### Addendum

SR 161  
JOVITA BLVD. TO SR 18  
WIDEN - STAGE 1  
STPF-1009(002) & STATE

**Addendum No. 3**

**Addendum No. 1**

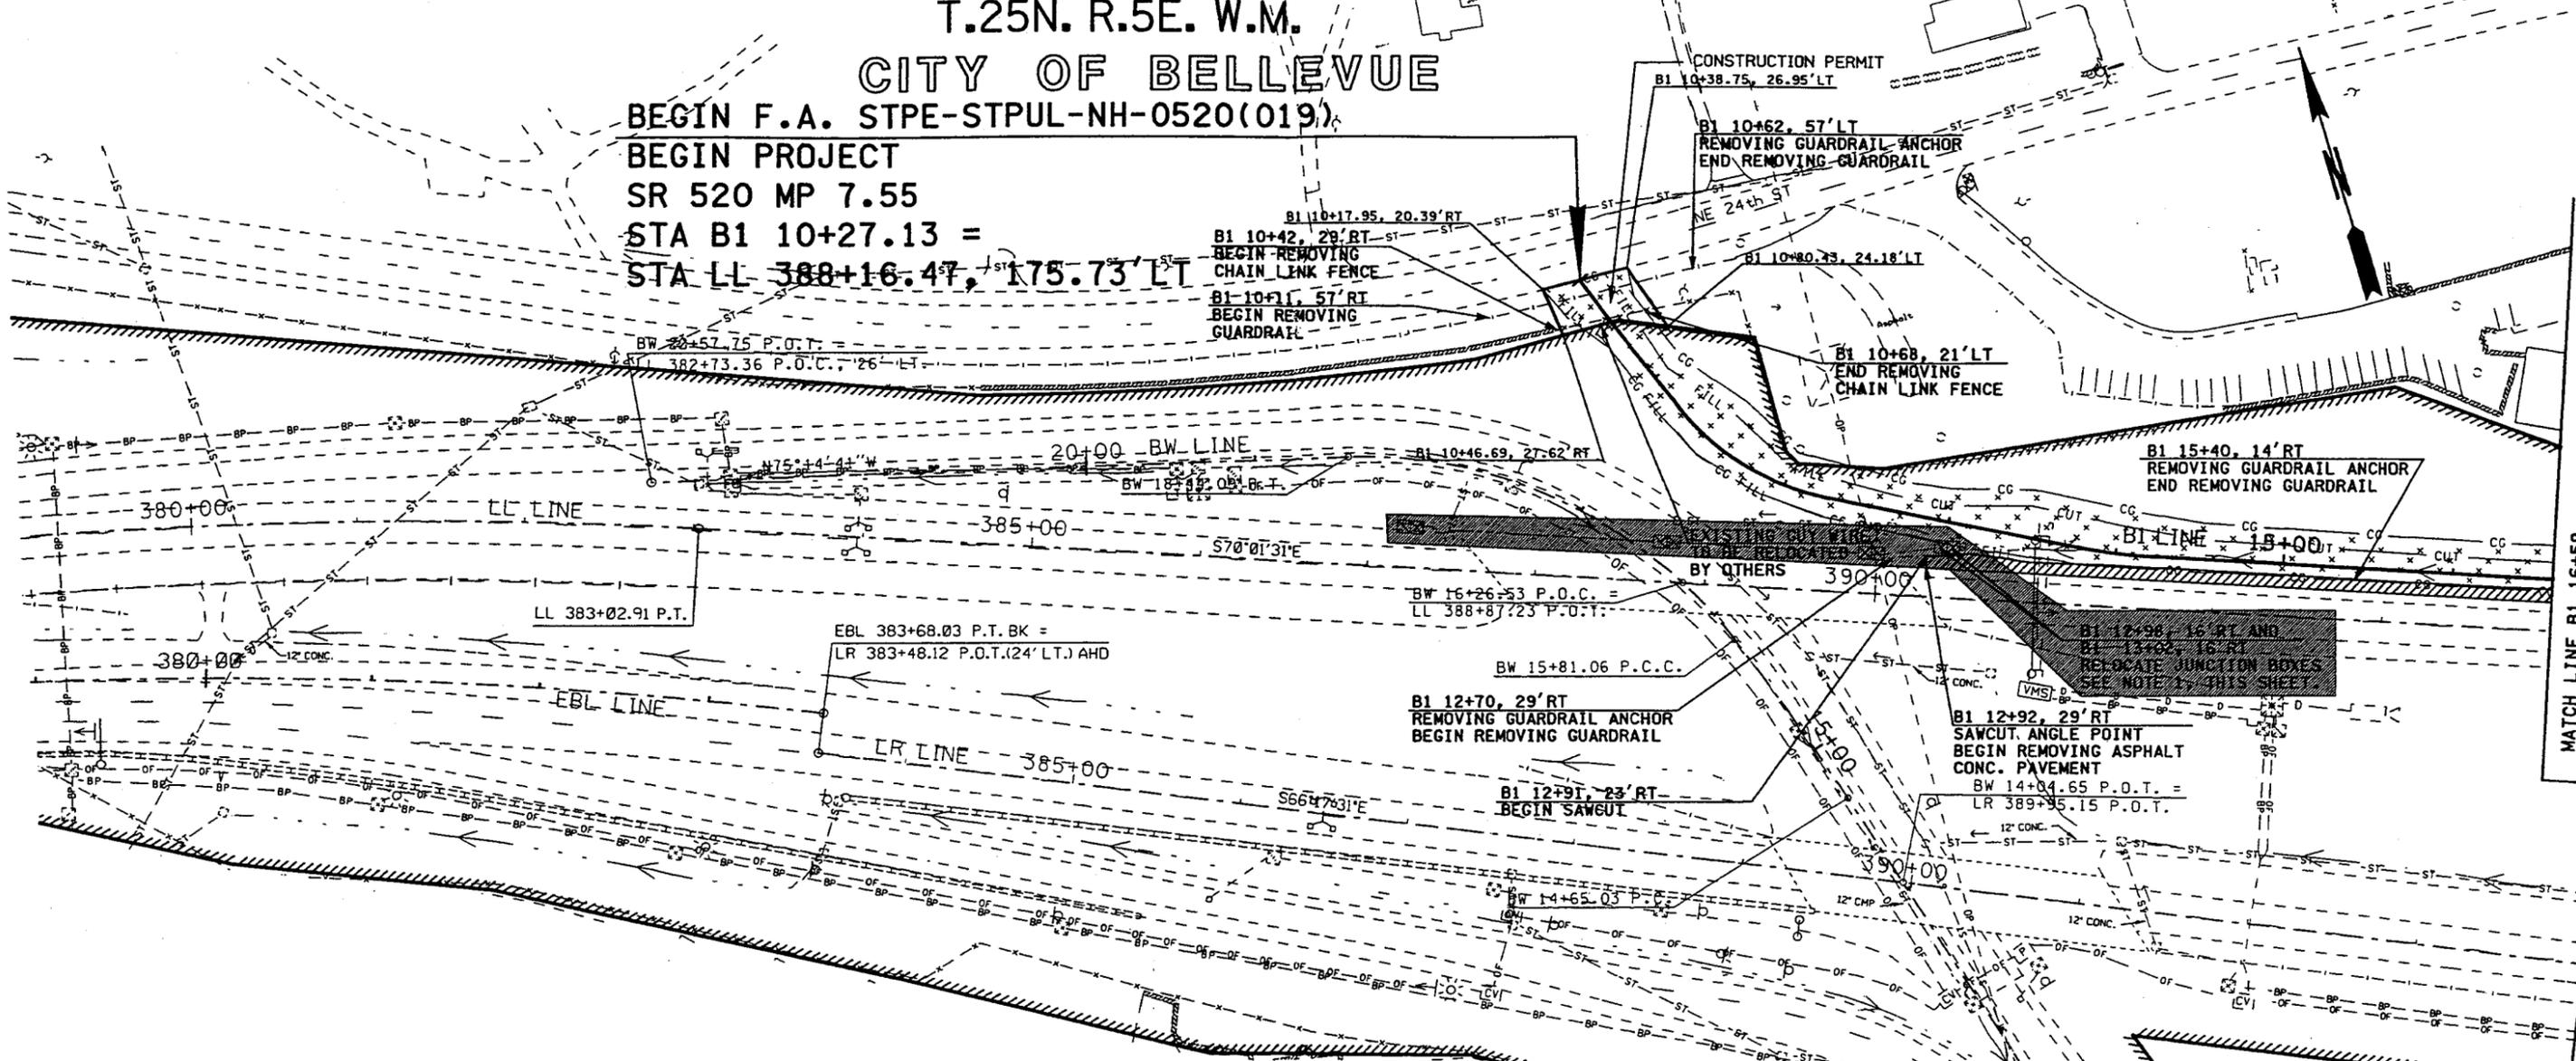
NOTES:  
 1. RELOCATE EXISTING JUNCTION BOX(ES) TO SOUTH SIDE OF NEW BARRIER, ALONG SR 520 SHOULDER, AS DIRECTED BY ENGINEER. INSTALL NEW TRAFFIC BEARING MODIFIED JUNCTION BOX(ES), AS SHOWN ON SHEETS U1 AND U2, AND ADJUST TO GRADE.

PS3  
SHEET  
14  
OF  
104  
SHEETS

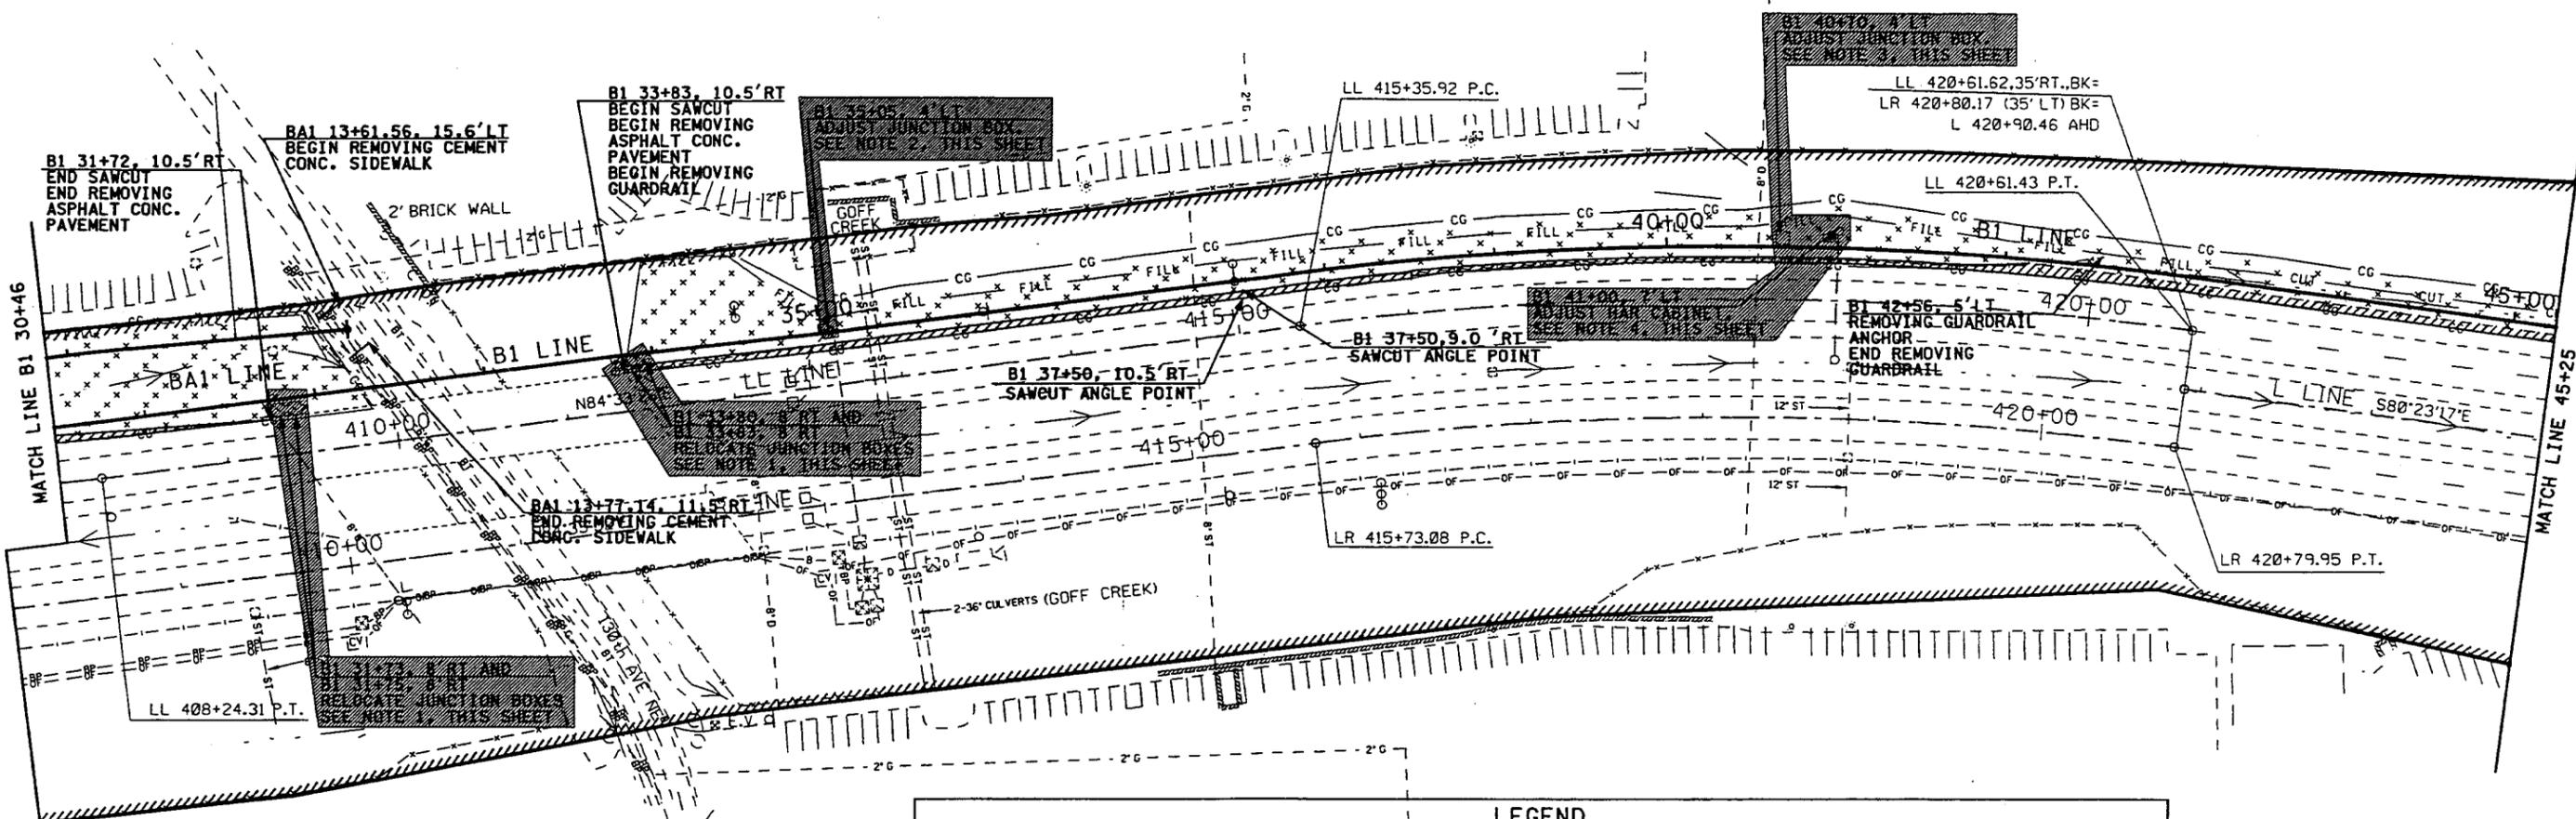
1. RELOCATE EXISTING JUNCTION BOX(S) TO SOUTH SIDE OF NEW BARRIER, ALONG SR 520 SHOULDER, AS DIRECTED BY ENGINEER. INSTALL NEW TRAFFIC BEARING MODIFIED JUNCTION BOX(S), AS SHOWN ON SHEETS 01 AND 02, AND ADJUST TO GRADE.
2. REMOVE EXISTING JUNCTION BOX AND INSTALL NEW TRAFFIC BEARING MODIFIED JUNCTION BOX AS SHOWN ON SHEETS 01 AND 02, AND ADJUST TO GRADE.
3. REMOVE EXISTING JUNCTION BOX AND INSTALL NEW TRAFFIC BEARING MODIFIED JUNCTION BOX AS SHOWN ON SHEETS 01 AND 02. PULL BACK EXISTING 2" #6 AND 1" #6 (TWISTED PAIR) CABLES, AND EXTEND CONDUIT. ADJUST JUNCTION BOX TO GRADE.
4. PULL BACK AND REINSTALL THE EXISTING 2" #6 AND 1" #6 (TWISTED PAIR) CABLES IN THE EXISTING HAS (HIGHWAY ADVISORY RADIO) CABINET.

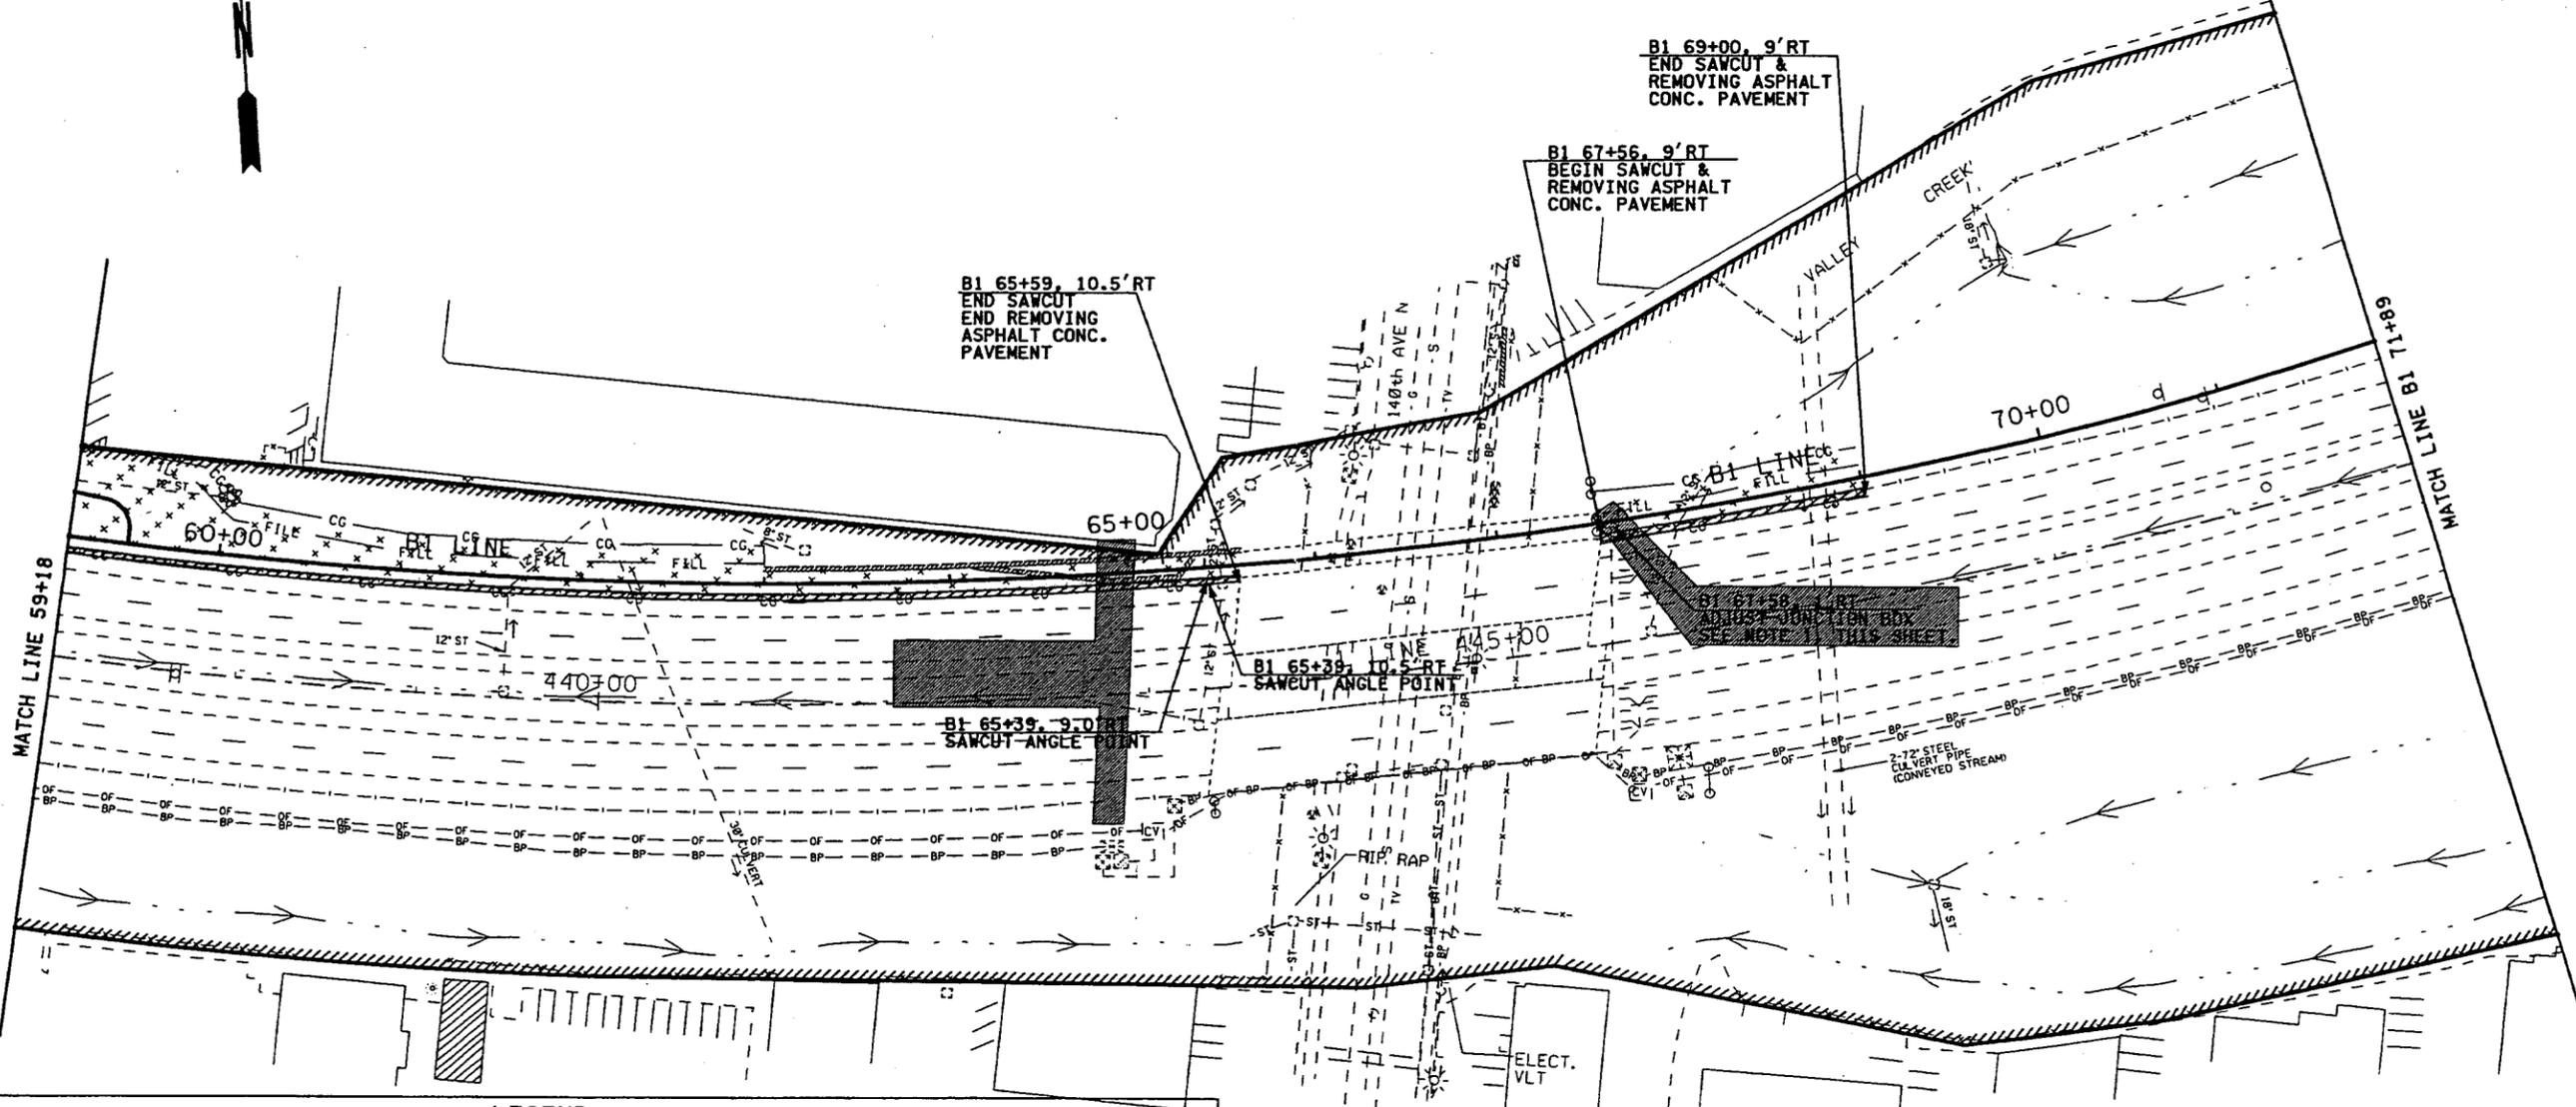
**NOTES:**  
 1. INSTALL NEW TRAFFIC BEARING MODIFIED JUNCTION BOX AS SHOWN ON SHEETS U1 AND U2, AND ADJUST TO GRADE.
